Memorandum

Date: June 16, 2020
To: Advisory Design Review Group
From: Patrick Streeter, Planning & Building Director
Subject: 70 Ivy Drive

Date: June 4, 2020
To: Advisory Design Review Group
From: Matthew Weintraub, Planner
Subject: 70 Ivy Drive

Precedents - Noise Mitigation

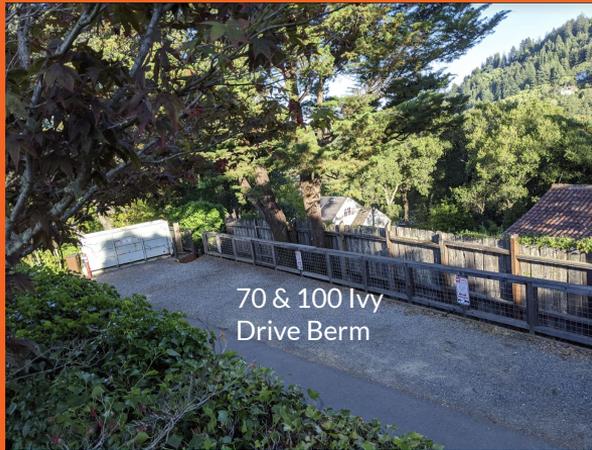
ADR: Add pool noise mitigation for neighbors at 102 Ivy

- Moved pool 3' farther away from the side setback. The pool is now 8' away from the side setback. The pool is 23' from the property line at the closest point and roughly 50' from 102 Ivy Drive's bedroom at the closest point. The Ching's do have hardscape within their setback extending along our shared fence.
- Increased the planting area between the fence from 3' to 4' and increased screening plants. We are open to specifying larger / more mature plants.
- Enlarged the water feature to create more "white noise"

- We did find two approved plans where neighbor noise concerns were addressed:
 - 45 Bolinas Avenue
 - Concerns from neighbors about pool noise
 - Applicant was asked to add trees along the common property line between the project site and neighbor.
 - 20 Lagunitas
 - Concerns from neighbors about driveway noise
 - Applicant was asked to provide a landscape buffer and screening along the common property line between the project site and neighbor
 - Applicant was asked to consider pavers over gravel to reduce the noise.
-

Ivy Drive Front Yard

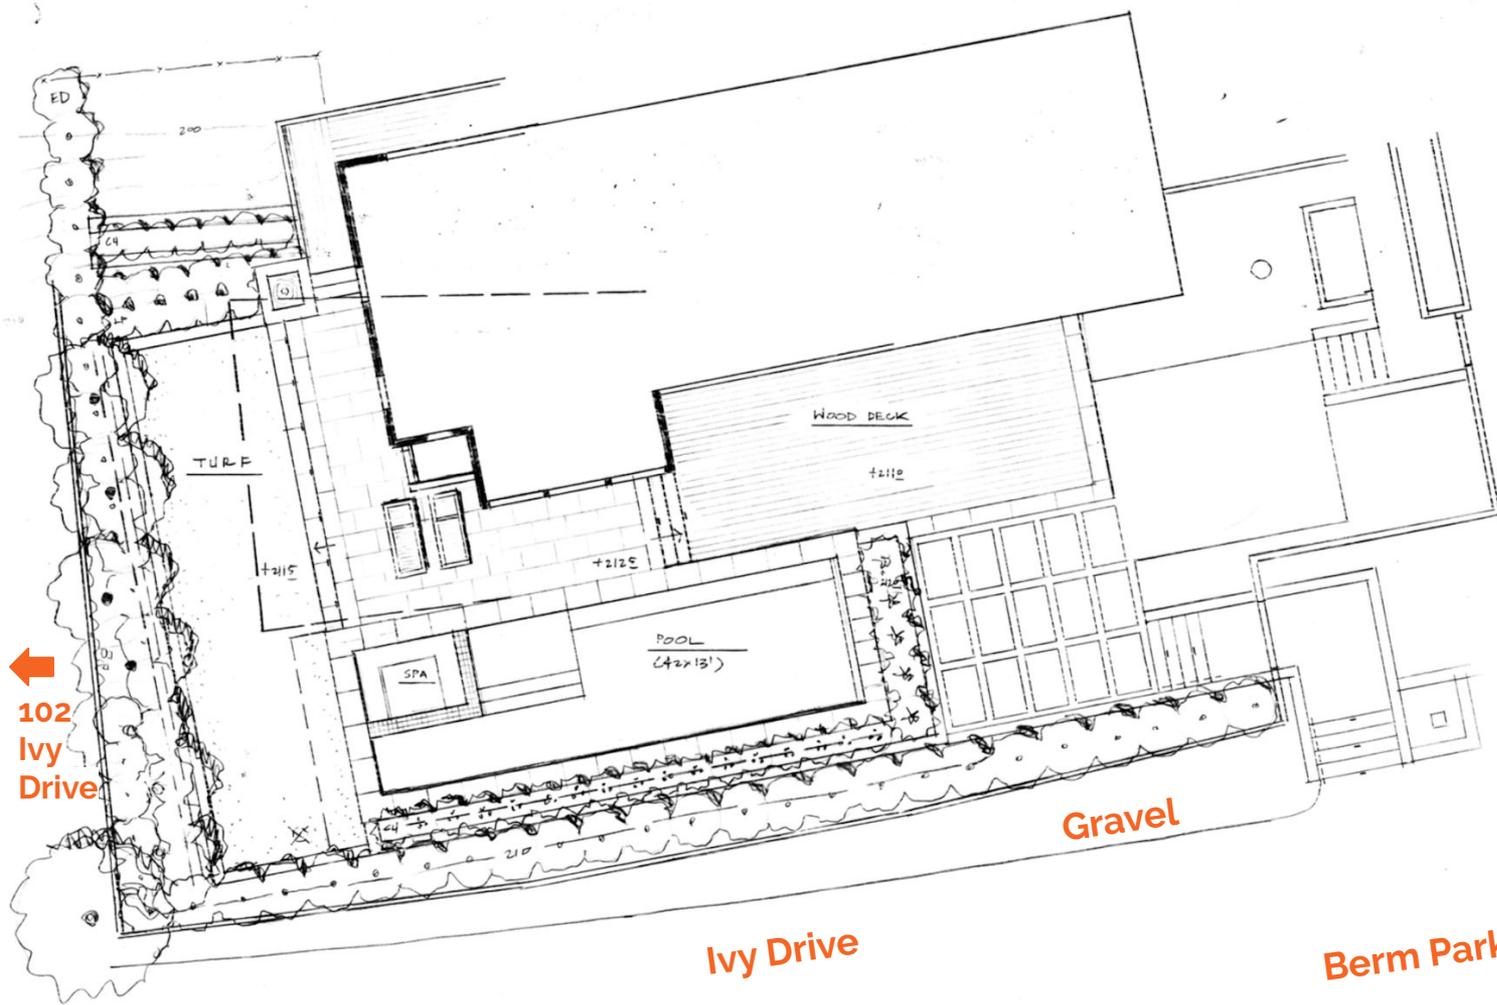
ADR: Concern that the pool was 4' from the road

- Pool water was originally 7' from the front property line and 12' from the paved road (4' was error)
- Pool is now 10' from the front property line and 15' from the paved road (an additional 3')
- Added a raised planter with additional screen planting along the street frontage

- On paper, the pool looks closer to the road than in reality
- Pool was staked (previous plan) for ADR to review in person
- From the edge of the paved road in front of our property, distance is 15' to pool
